Engineering Bulletin – Lyric 09 Revision 2

Lyric 09 All-In-One

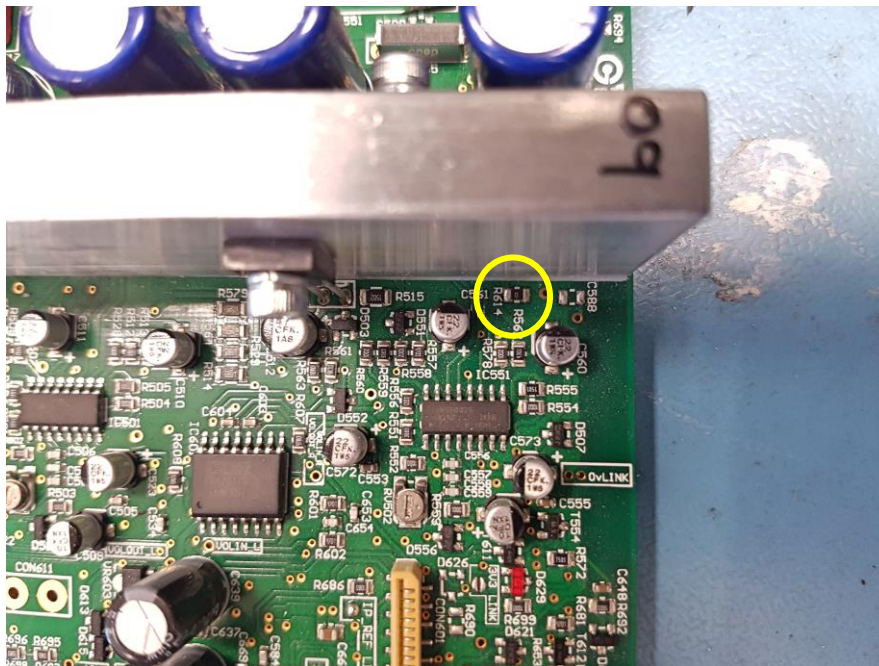
- Change R614 from 0R0 to 4.7uF SMD0805, X5R, 6.3V capacitor (<http://uk.farnell.com/kemet/c0805c475k9pactu/cap-mlcc-x5r-4-7uf-6-3v-0805/dp/9227857>)

- Change R615 from 0R0 to 4.7uF SMD0805, X5R, 6.3V capacitor (<http://uk.farnell.com/kemet/c0805c475k9pactu/cap-mlcc-x5r-4-7uf-6-3v-0805/dp/9227857>)
